FOUR COUNTY SC LIDAR QUALITY ASSURANCE YORK COUNTY REVIEW

UNITED STATES GEOLOGIC SURVEY
AND
SOUTH CAROLINA DEPARTMENT OF NATURAL
RESOURCES

USGS CONTRACT: G10PC00025
TASK ORDER G11PD01086

First review: October 15, 2011
Second review: February 17, 2012

Figure 2: Overall project flightline exhibit (left) and enlarged view (right)

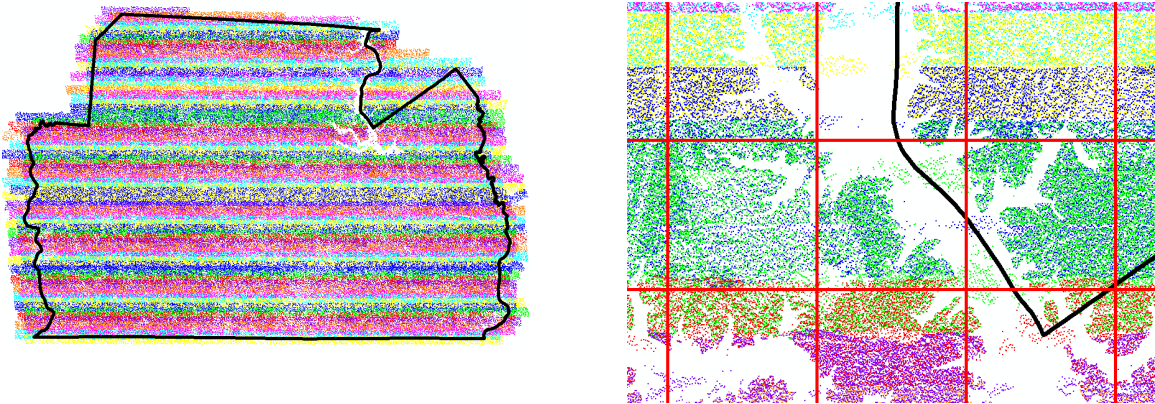
The first item outlined in the Criteria states that flightlines are directed to be flown as planned with 10% minimum sidelap between flight lines. The flightlines were flown with a sidelap of 45 to 50%. The collected data couldn't have holidays and needed to have periodic and local calibration checks. No holidays were noted in the review of 10% of the project area. The exhibits below show the extents of sidelap:

Figure 3: York County Checkpoints

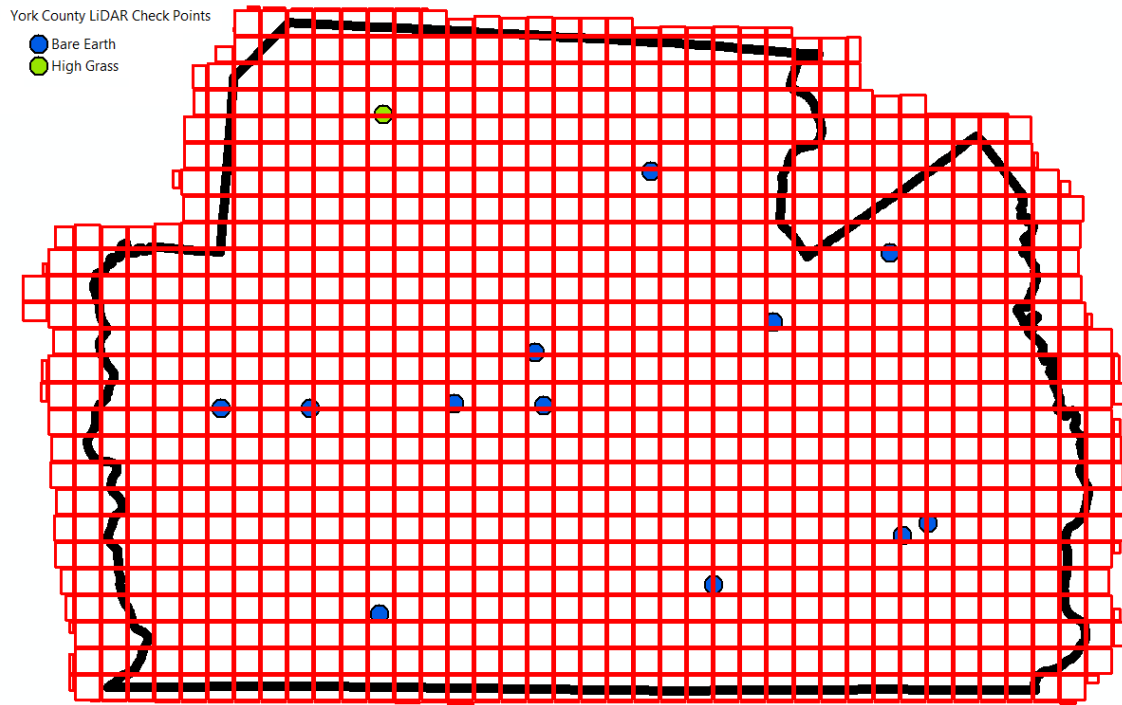
The Criteria also requires GPS baseline lengths to be less than 25 miles. The GPS baseline lengths are established by the distance between check points. Thirteen check points were collected for the York County data collection – twelve points are classified as bare earth and one is classified as high grass. The figure below shows the location of said checkpoints in relation to York County and the provided tiles.

Figure 4: Forward vs. Reverse Post-Processed Solution – Lift 071B

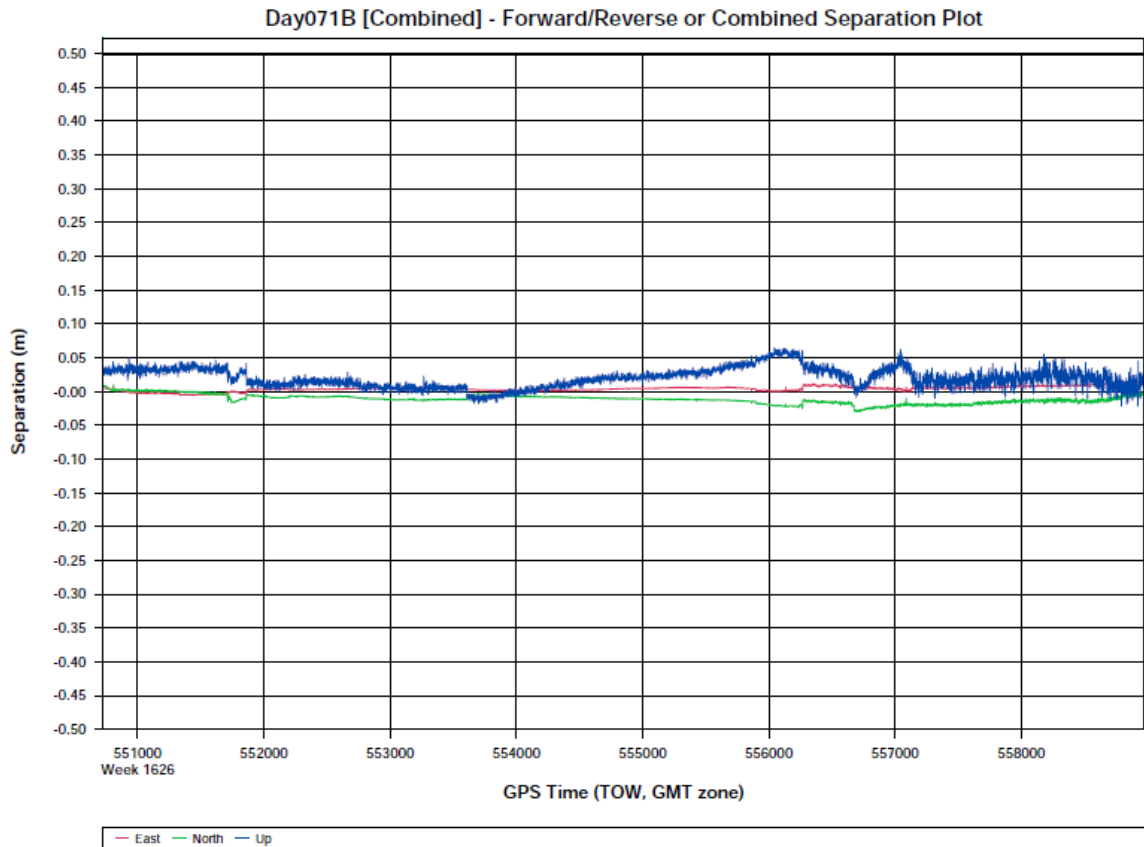
Additionally, the Criteria requires the GPS trajectories to be evaluated with forward and reverse comparisons within 10-20 cm. The GPS solution chart below, as provided by Dewberry, shows forward and reverse comparisons within 3 - 6 cm.
